# Access Compliance Report Public Rights-of-Way (Curb Ramps)

**Main Street: PURDY\_ST** **Cross Street: HAZARD\_AVE** **Location: NE**

**ADA ID: RPRK220203121510** **Ramp Type: Type 4 - Parallel** **Initial Pass/Fail: Fail** **Overall Compliance: No** **Severity Score: 2**

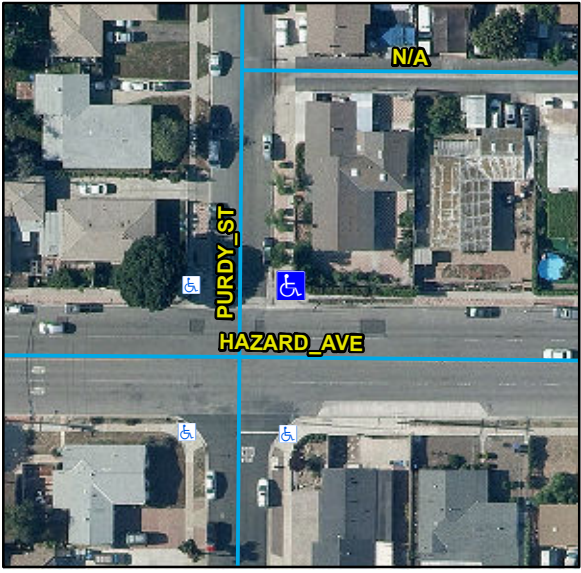
Compliance	Description	Data	Compliance	Description	Data
N/A	Ramp Length LT (in)	111	N/A	Ramp Length RT (in)	124
Yes	Ramp Width LT (in)	102	Yes	Ramp Width RT (in)	102
Yes	Ramp Run Slope LT (%)	4.4	Yes	Ramp Run Slope RT (%)	7
No	Ramp Cross Slope LT (%)	2.8	No	Ramp Cross Slope RT (%)	3.5
N/A	Landing Present	N/A	N/A	DWS Provided	N/A
N/A	Landing Length (in)	N/A	N/A	DWS Contrast	N/A
N/A	Landing Width (in)	N/A	N/A	DWS Length (in)	N/A
N/A	Landing Run Slope (%)	N/A	N/A	DWS Full Width	N/A
N/A	Landing Cross Slope (%)	N/A		DWS Offset Type	N/A
N/A	Landing Movement Obstructed?	N/A	N/A	DWS Offset Left (in)	N/A
	Landing Movement Type	N/A	N/A	DWS Offset Right (in)	N/A
N/A	Landing Shared	N/A			
N/A	Clear Space	Yes			
N/A	Clear Space To Crosswalk (in)	N/A			
N/A	Marked Crosswalk 1	No	N/A	Marked Crosswalk 2	No
	Crossing 1 Direction	W		Crossing 2 Direction	S
N/A	Marked Crosswalk 1 Width (in)	N/A		Marked Crosswalk 2 Width (in)	N/A

Possible Solutions:  
**Remove & Replace Curb Ramp With Two New Directional Ramps or Equivalent.**

OC Std/PROW:  
**R204.3, R304.5.3, STD 1115**
